Product / Process Change Notification (PCN)

PCN #: PCN_SwTATV_20180523

Affected Series: 430 1x6 xxx 7x6

BEFORE**AFTER**

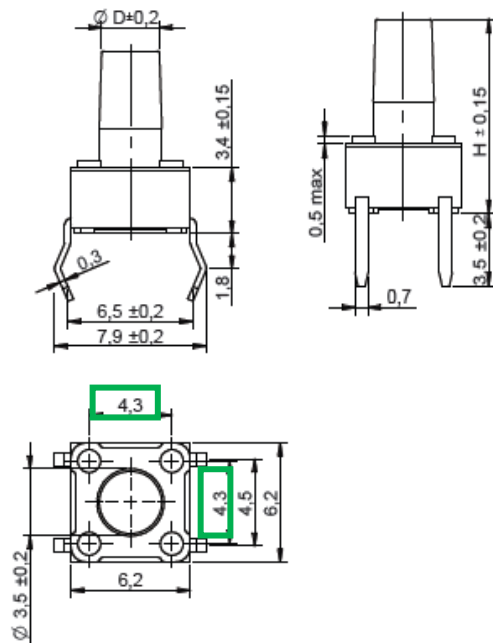
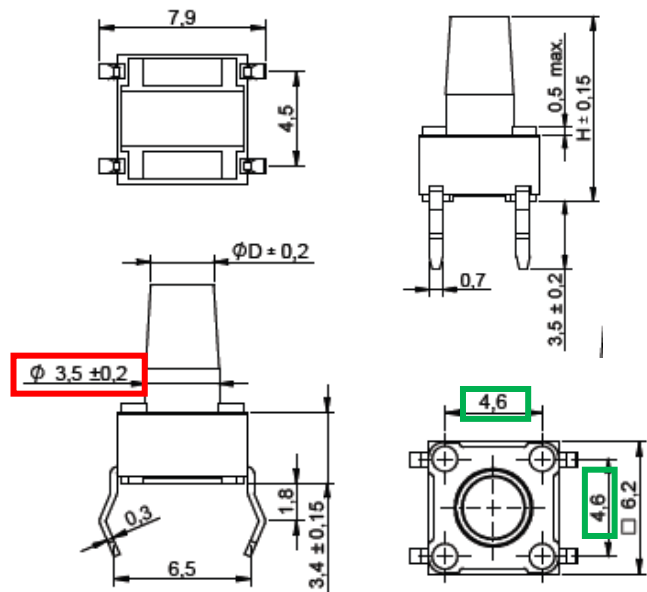
1. Adding the new parameter 3.5 ± 0.2 for the max. width of actuator.
2. Correcting the distance between two positioning holes of the cover because of a datasheet mismatch from 4.3 ± 0.1 to 4.6 ± 0.1 .
